Proposed Temporary Warehouse & Open Storage (Excluding Dangerous Goods) with Ancillary Facilities & Associated Filling of Land for a Period of 3 Years at Lots 1299, 1305 S.A (Part), 1305 S.B RP (Part), 1306 S.A, 1306 S.B (Part), 1307, 1308, 1309 RP, 1310, 1317 RP, 1318, 1360 (Part), 1392 (Part), 1393 (Part), 1394, 1395, 1396, 1397, 1398 S.A & B, 1399 (Part), 1402 (Part), 1403 (Part), 1407, 1408, 1409, 1410, 1411, 1412, 1413, 1414, 1415, 1416, 1417, 1418, 1419, 1421, 1422, 1423, 1424, 1425, 1426, 1427, 1428 (Part), 1429, 1430, 1431, 1433, 1434 (Part), 1435 (Part), 1538 (Part), 1539 (Part) and 1540 in D.D.118 and Adjoining Government Land, Tai Shu Ha Road West, Tai Tong, Yuen Long, N.T.

In response to the further comments of CE/MN, DSD, we are glad to submit the response to comments in the attachment.

Comments		Responses
Comments from Drainage Services Department received 25 Aug 2026 via email [Contact person: Mr. LOU Tai-yeong, Tel: 3965 8929]		
General

DRAINAGE IMPACT ASSESSMENT

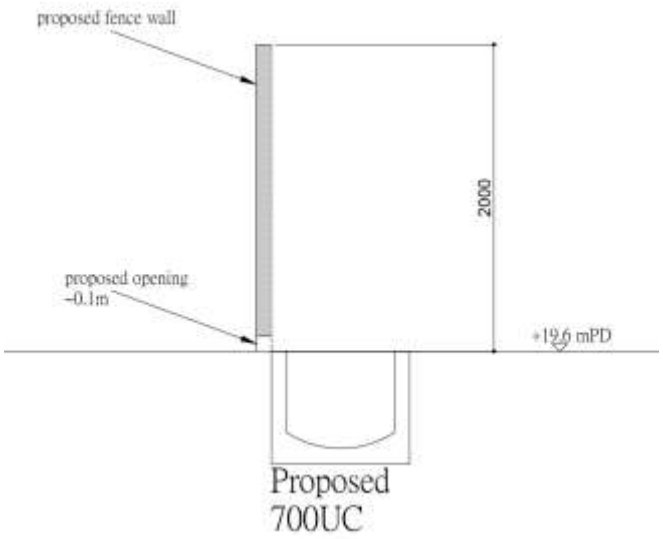
3.	R-to-C item 11 – Please provide details of the fence wall openings in the drawing.	Noted. The section diagrams are provided as follow. The fence wall of about 2mH will be erected along the Site boundary, with about 0.1m above the footing would be reserved as openings to intercept the overland flow passing through the site. In the diagram, the site level of +19.6mPD is for reference only.

Drawing No :	Revision :
FIGURE 2.2a	0
Scale : AS SHOWN	Date : JUN 2026

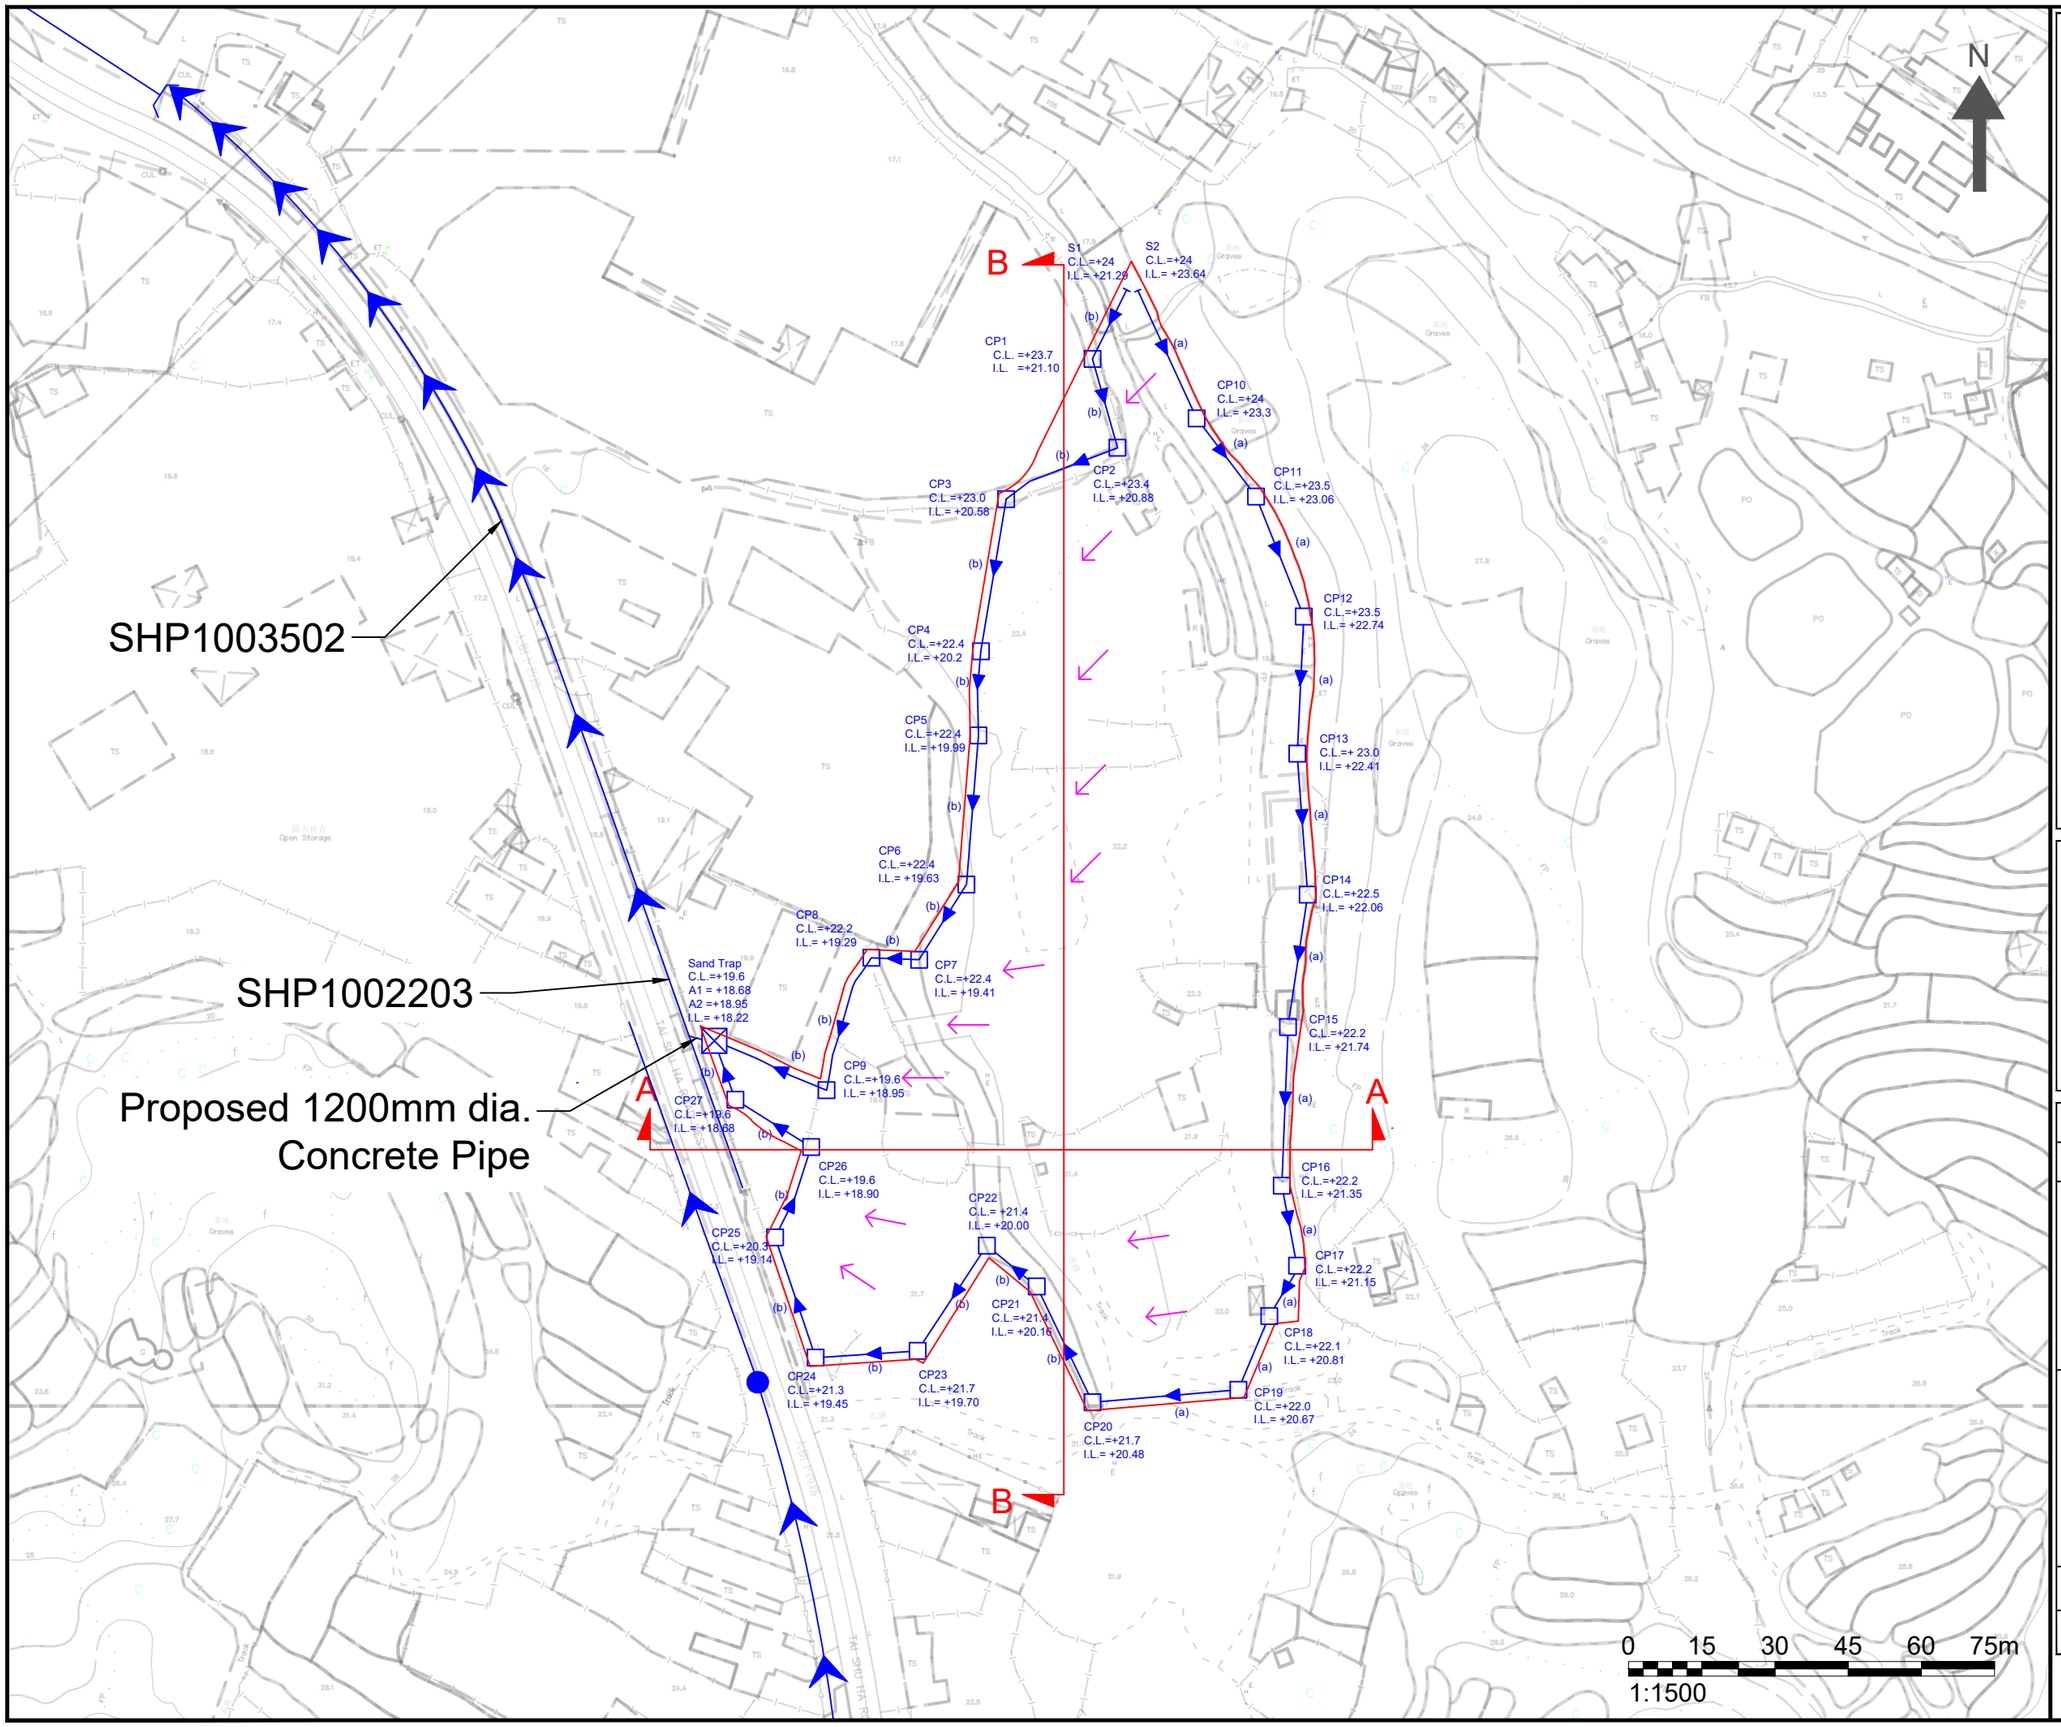
2.	R-to-C item 3 – Please clarify which part of Figure 2.2a is revised for the grating of surface channels.	The surface channel with cast iron cover shown in legend of Fig 2.2a.

8.	Figure 2.2a – Please provide details of connection/section of the proposed 900mm underground pipe connecting the proposed sand trap and the existing channel (including the gradient and invert levels of the inlets, outlets and channel). Please also indicate the proposed 900mm underground pipe accordingly.	The details of connection is provided in Figure 2.4, the proposed 1200mm underground pipe is indicated in Fig 2.2a.

9.	Figure 2.2a – Please indicate the existing drainage facilities (including its type and size) in the vicinity of the application site for clarity.	Noted, existing box culvert were shown in Figure 2.2a

12.	Figure 2.2a & Appendix C – There is a discrepancy between Figure 2.2a and Appendix C. Figure 2.2a suggests a 700mm u-channel around the site, while Appendix C mentions a 375mm U-channel between CP10 and CP21. Please check and amend accordingly.	Noted, Figure 2.2a and App C are revised and tally.

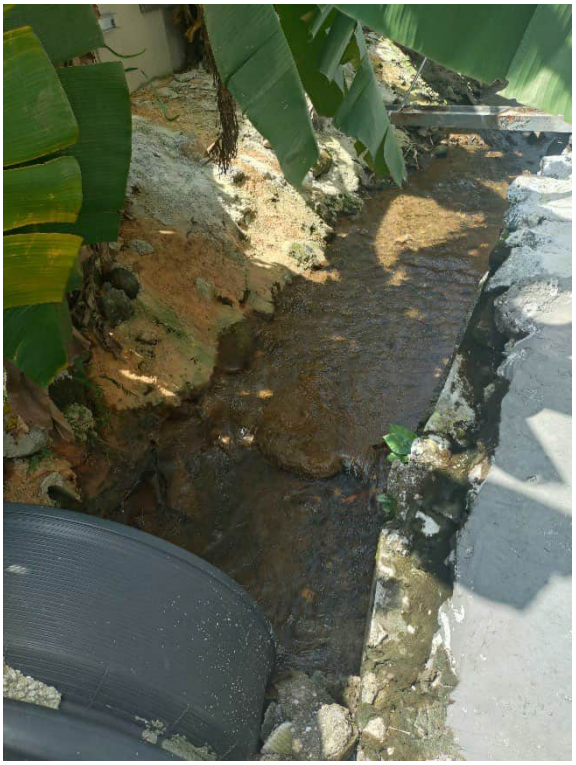
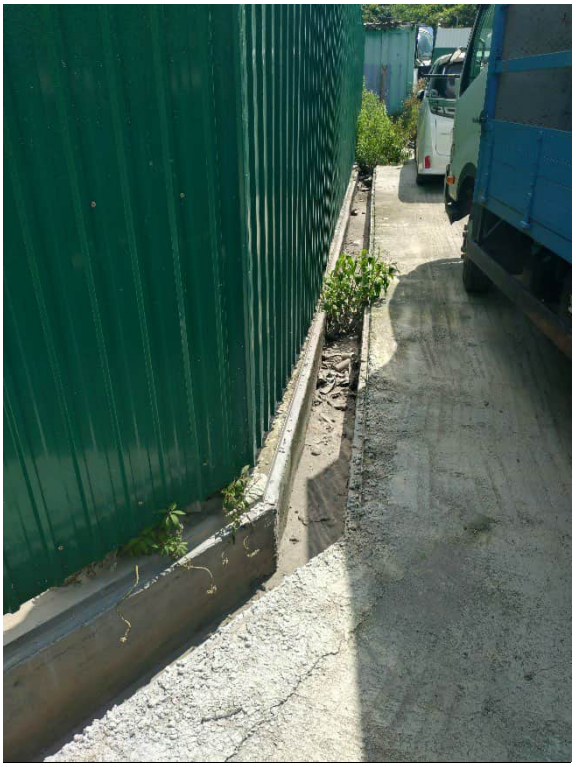
16.	"Calculation for Depth of Flow, y" in Appendix C – Please review the width of the existing channel which seems to be less than 11m based on Photos 5 & 6 in Appendix D. Please also provide further site photos along the proposed discharge path to ascertain your assumed channel width.	The actual width and depth of the existing channel are assumed to be 2m in width and 1m in depth, the relevant section and calculation are revised accordingly.

CATCHPIT WITH TRAP (SHEET 1 OF 2)

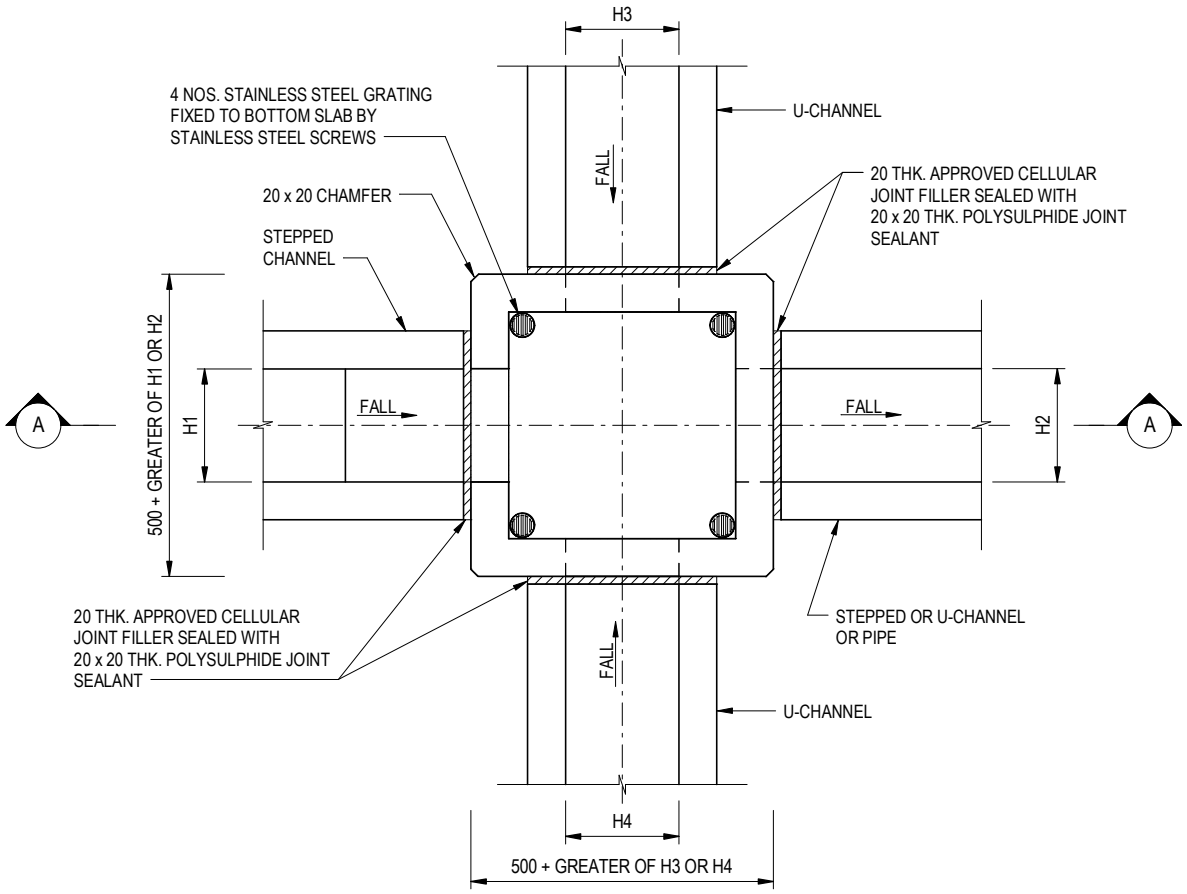
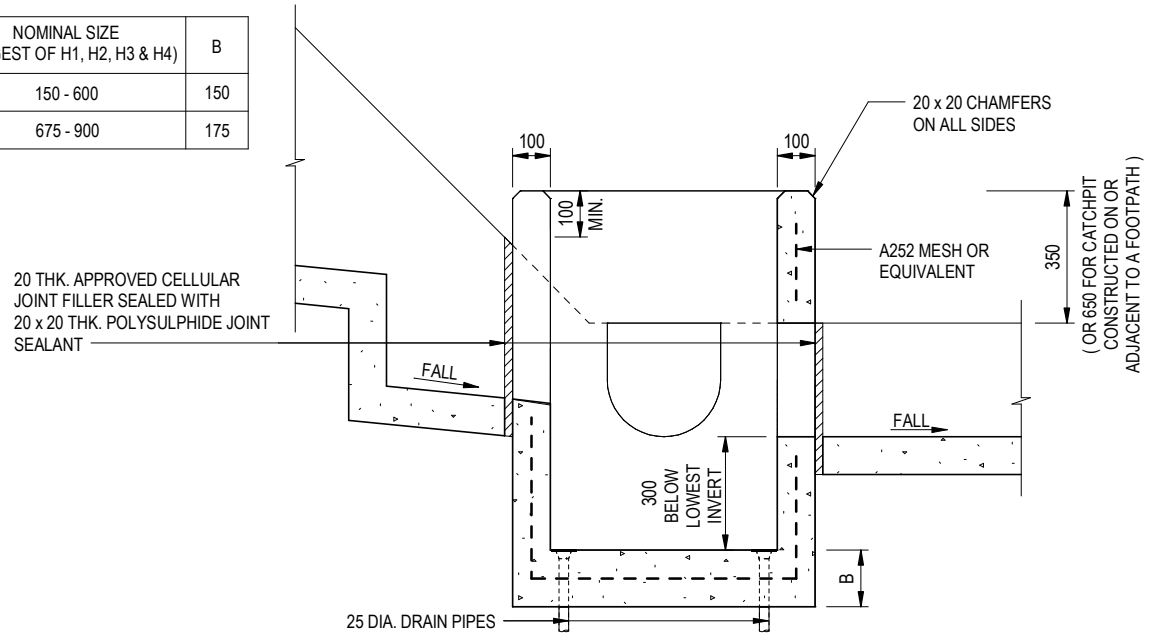
4.	R-to-C item 13 – Standard details of the catchpit with sand trap is missing in Appendix E, please review.	Standard drawing of catchpit with trap is added in App E.
5.	Section 2.1 – The existing underground pipe within the application site should be properly maintained by the applicant to ensure no obstruction to nor adversely affect the existing discharge path of the upstream areas, please update Section 3 accordingly. Please also review if Appendix XX is correct.	Noted, S.2.1.3 is revised accordingly, Appendix D is added. S.3.1.4 is added.
6.	Table 2-1 – The proposed channel size of 600mm for Catchment A is not consistent with 700mm in Figure 2.2a. Please review.	Table 2-1 is revised accordingly.
7.	Figure 2.2a – Catchpit should be provided at the turning point of the proposed u-channel between CP17 and CP18. Please review.	Noted, catchpit is added.
